Duke Energy Ohio
Case No. 19-2163-EL-BLN
STAFF Second Set of Data Requests
Date Received: Friday, January 24, 2020

STAFF-DR-02-001

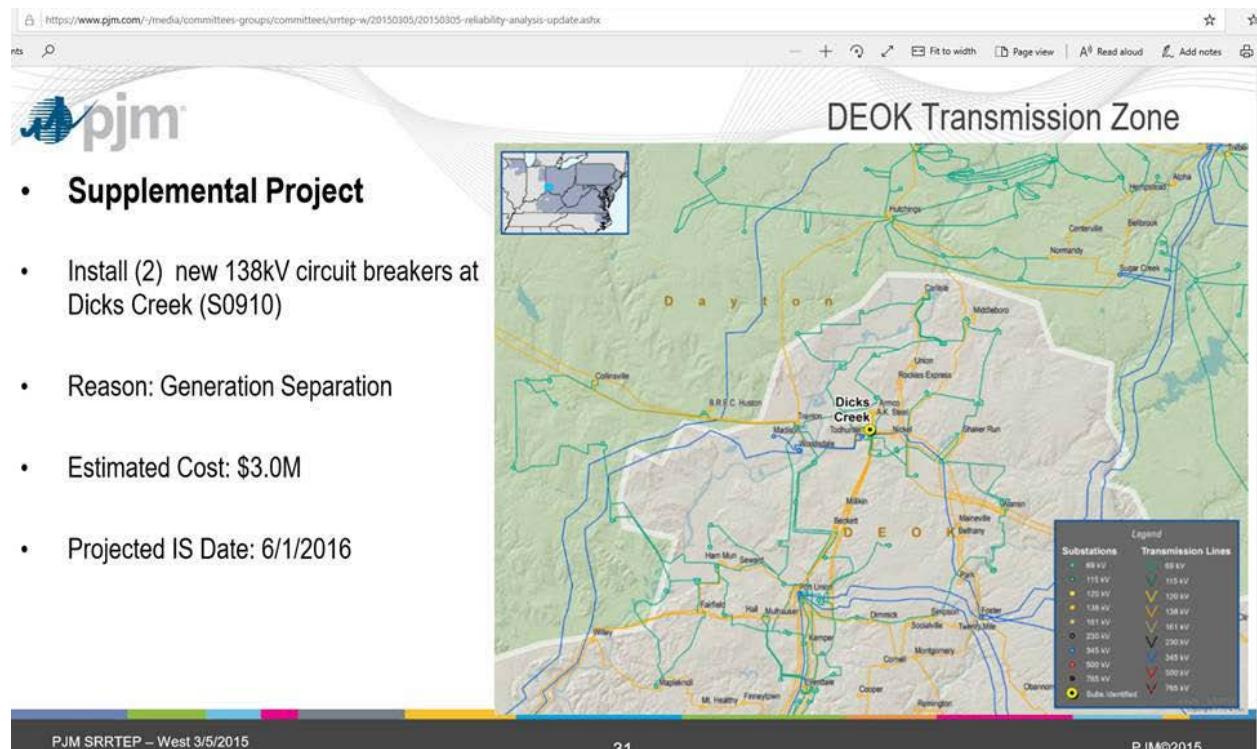
Staff finds that the project descriptions in 19-2163-EL-BLN and the LTFR seem more extensive than the project description in supplemental project number, S0910:

Please clarify the additional items listed in the project description in 19-2163-EL-BLN and the LTFR.

In 2015, the analysis was completed at a very high level to determine the scope. The detailed engineering of the project identified the additional scope items as being necessary (substation expansion, retaining wall, transmission line work, transmission structure replacement), as described in Section 4906-6-05(B)(1).
